ADDENDUM #5
DSA # 01-117794
Pioneer ES New Classroom Addition
DSA File # 1-25

DSA #01-118098
Pioneer ES Interim Housing
DSA File #- 1-25

May 29, 2019

Project: **Pioneer ES New Classroom Addition**
Pioneer ES Interim Housing
32737 Bel Aire St
Union City, CA 94587

SITE ELECTRICAL PLAN

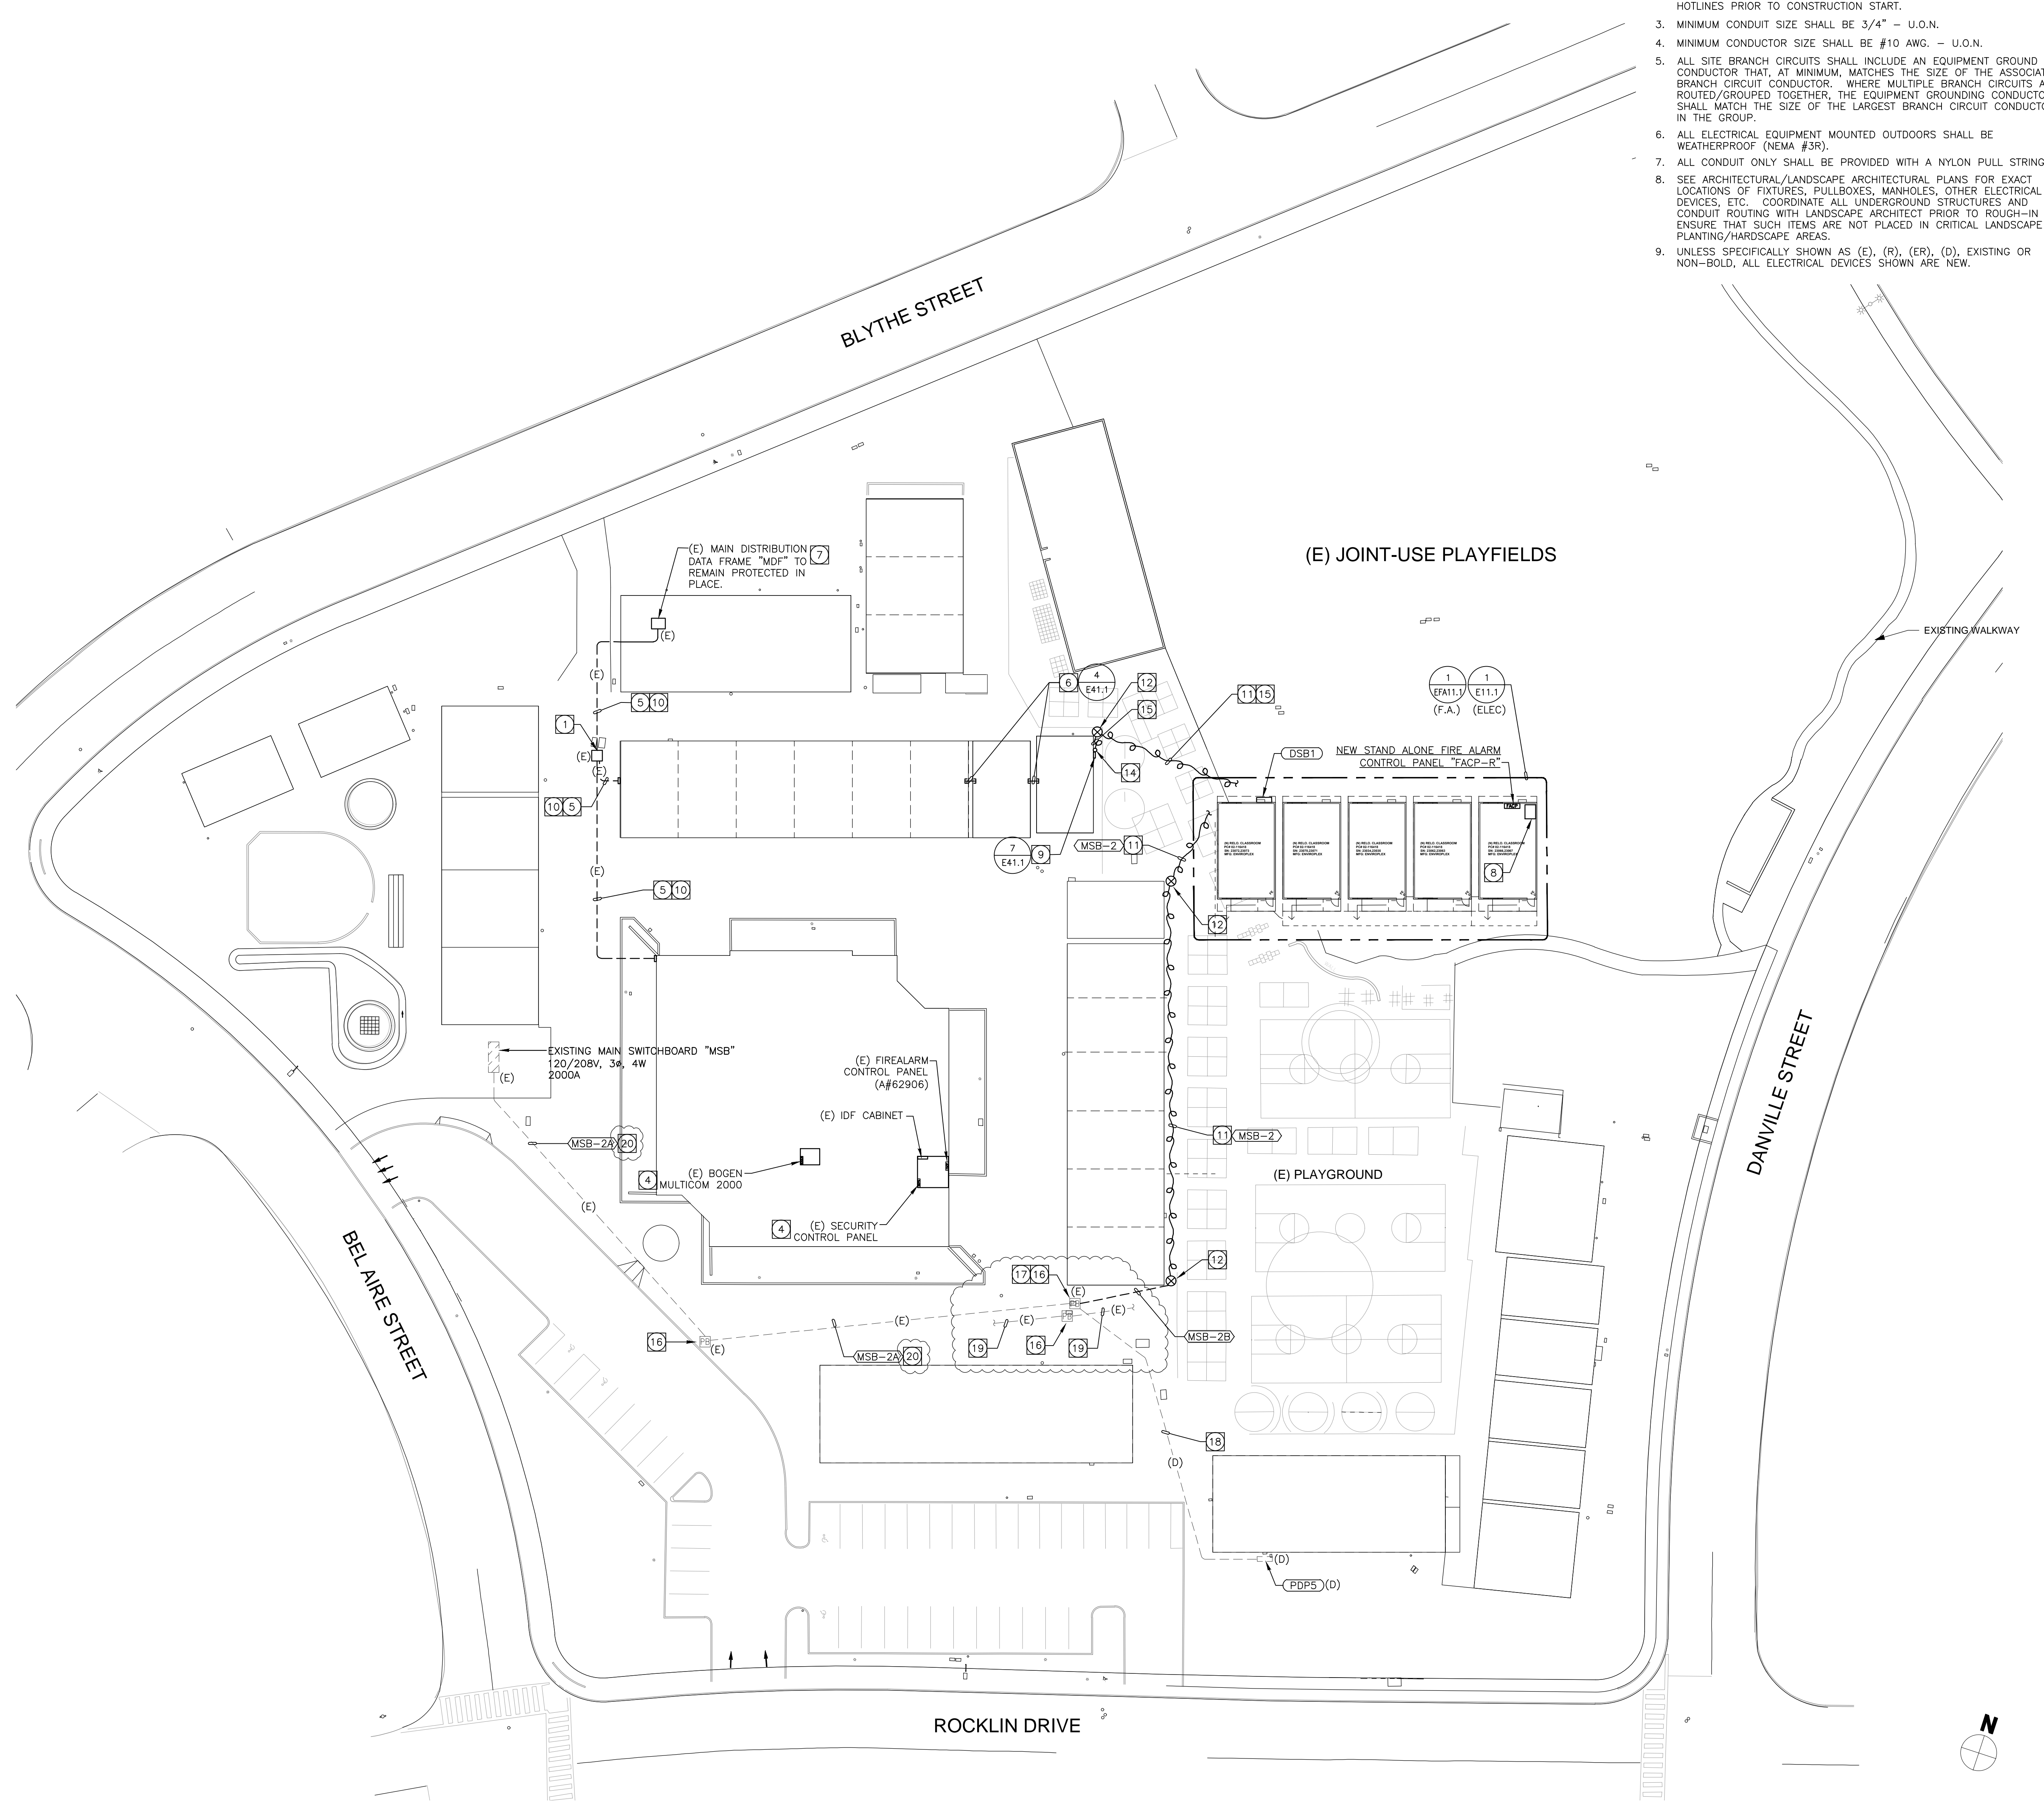
Sheet E01.1 – Site Electrical Plan:

1. Revised site conduit routing per revised sheet E01.1.
2. Added plan notes 19 and 20.
3. Revised plan note 18.
